INDEPENDENT MONITORING PANEL FOR SPRINGVALE MINE

ADVICE RE:

**SPRINGVALE COAL MINE
EXTRACTION PLAN
LONGWALLS 428-432**

November 2021

Figure 1: Hanging swamp locations in the vicinity of LW 428 to 432 as now advised to the Panel (the mine design is as originally planned - it does not reflect the recent proposal to shorten LW431 and LW432).

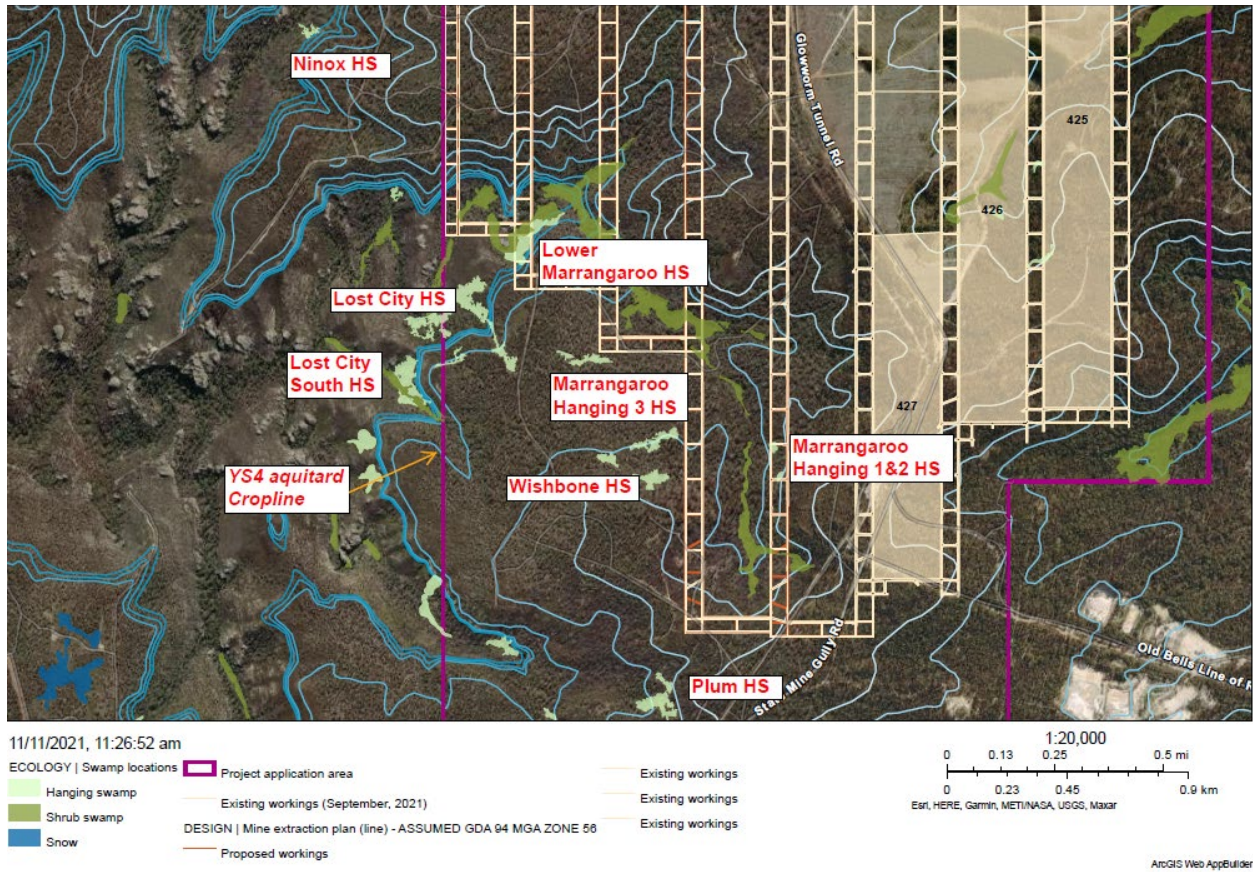
Figure 1 of this advice has been prepared by the Panel on the basis of the latest mapping and advice from Centennial Coal in response to the Panel's queries and is a slight update of Figure 4 of RPS (2021) that shows the type and location of swamps identified by RPS in the vicinity of LW428-432. Notable outcomes are:

- Small swamps previously mapped as shrub swamp overlying the roadway area between LW428 and LW429 have been reclassified and named Marrangaroo Hanging Swamp 1 and Marrangaroo Hanging Swamp 2.

- A previously unnamed hanging swamp located just beyond the southwest corner of LW430 has been named Marrangaroo Hanging Swamp 3.
- A 300 m x 50 m section of Lower Marrangaroo Shrub Swamp south of LW431-432 has been reclassified as Lower Marrangaroo Hanging Swamp.

- The transitional hanging swamp areas adjacent to the Marrangaroo Shrub Swamp areas in the lower Marrangaroo Creek area west of LW430 and south of LW431 have floristic characteristics similar to Marrangaroo Shrub Swamp and are now mapped as shrub swamps.

- Neither Figure 1 of this advice nor Figure 4 of RPS (2021) record the hanging swamp shown within the footprint of LW432 in the *Springvale Longwall 428-432 Extraction Plan Adaptive Management Mine Design Justification Report* (the 'Mine Design Justification Report'), prepared in August 2021 and reproduced as Figure 2 of this Panel advice. This area has been reclassified as part of the Marrangaroo Shrub Swamp.

- The only hanging swamps that occur below the YS4 aquitard in the vicinity of the proposed longwalls are Lower Marrangaroo (south of LW431-432), most of the Lost City complex located south of LW432 and Ninox located west of LW432. The remaining hanging swamps (Marrangaroo Hanging Swamps 1, 2 and 3, Wishbone, Lost City (upper), and Plum all occur above the YS4 aquitard.

Figure 3: Conceptual hydrogeological models of changed groundwater flowpaths resulting from longwall mining

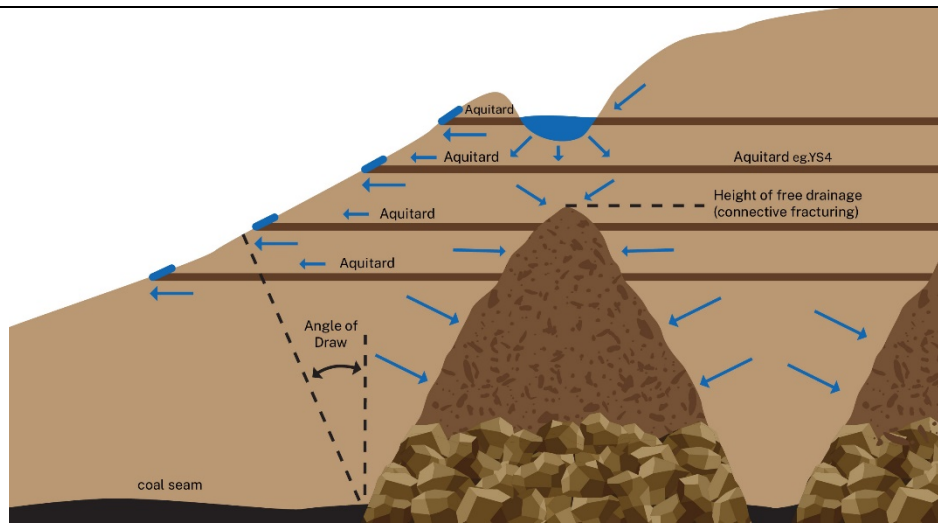
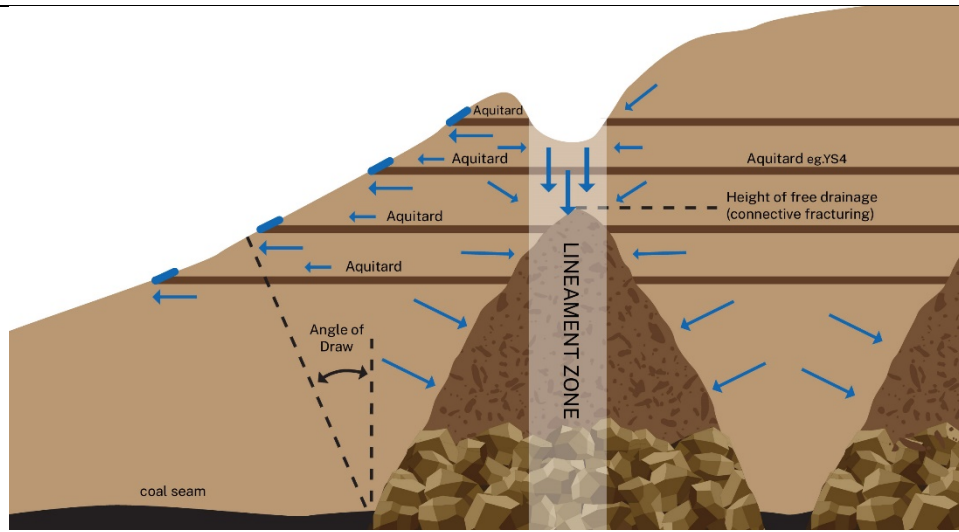
Mining induced impacts on the groundwater regime in the vicinity of LW428-432 can be conceptualised as follows and are shown schematically in Figure 3(a) and 3(b):

- Free drainage of groundwater from deep aquifers into the goaf area immediately above the longwall (i.e. primarily from the Illawarra Coal Measures and lower Narrabeen Group formations where there is connective fracturing to the mine workings).

- Tortuous flow of groundwater from shallow aquifers in the Banks Wall Sandstone and (lower) perched aquifers in the Burrallow Formation towards the goaf area from the constrained zone located above and adjacent to the goaf area.

- Uncertain impacts on flow of groundwater in the (upper) perched aquifers in the Burrallow Formations in the area above and adjacent to the constrained zone that sustain hanging swamps.

- Enhanced flow and drainage of groundwater from multiple aquifers along basement lineaments that are reactivated due to slippage resulting from mining induced stresses. These lineament features extend near-vertically, potentially connecting perched aquifers to the goaf area

Figure 4: Existing groundwater monitoring locations in the vicinity of longwall panels 428 to 432

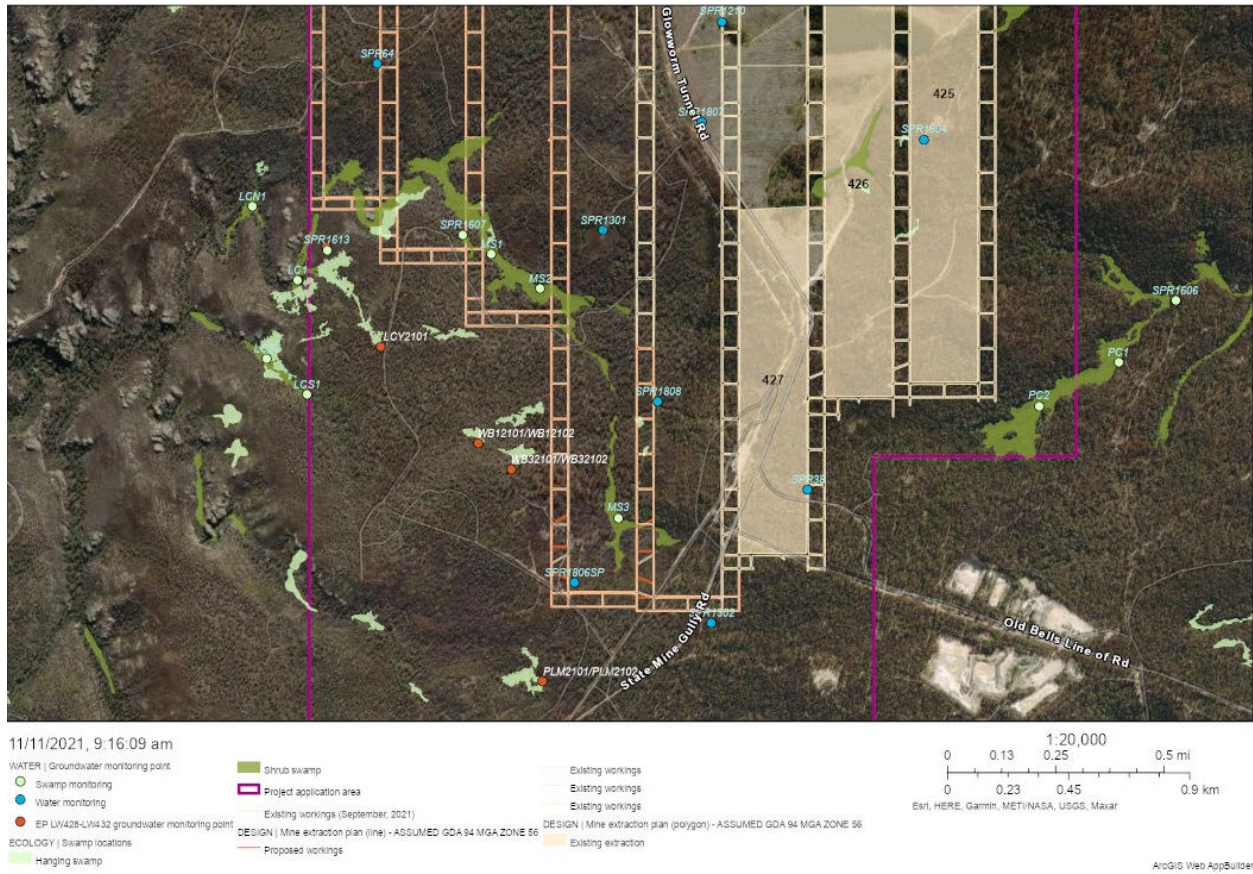
The location of the existing groundwater monitoring locations in relation to each of the shrub swamps and hanging swamps is shown in Figure 4.

Summary details of all the shallow groundwater monitoring locations in the vicinity of both the shrub swamps and the hanging swamps are provided in Table 1, with the locations proposed by the Panel indicated in italics. The Panel notes that these locations were discussed with Centennial staff and consultants on its field trip of 27 October 2021, although no formal agreement was made at that meeting. Swamp piezometers are those located in saturated swamp colluvium; shallow aquifer piezometers are mostly those located at the base of the Burralow Formation in AQ5; and perched aquifer piezometers are mostly those located in the upper Burralow Formation above the YS4 aquitard in AQ6.

It is acknowledged there are additional existing ridge piezometers and VWPs overlying and adjacent to these longwall panels in deeper aquifers that are not included in Table 1 and which should continue to be monitored as part of the WMP

The Panel recommends additional groundwater monitoring to assess the shallow groundwater trends more comprehensively (particularly groundwater levels in the swamp colluvium and underlying Buralow Formation perched aquifers) at a number of key sites. These are in addition to the recently constructed sites at Plum, Wishbone and (upper) Lost City hanging swamps. The recommended new sites are listed in Table 1 and are:

- One swamp piezometer at Lower Marrangaroo Hanging Swamp
- Four swamp piezometers at (eastern) Wishbone Hanging Swamp north of WB32101/32102 locations
- One deeper shallow aquifer piezometer at (eastern) Wishbone Hanging Swamp beside the WB32101/32102 locations
- One swamp piezometer at Marrangaroo Hanging Swamp 1
- Two perched aquifer piezometers at Marrangaroo Hanging Swamp 1
- One swamp piezometer at Marrangaroo Hanging Swamp 3
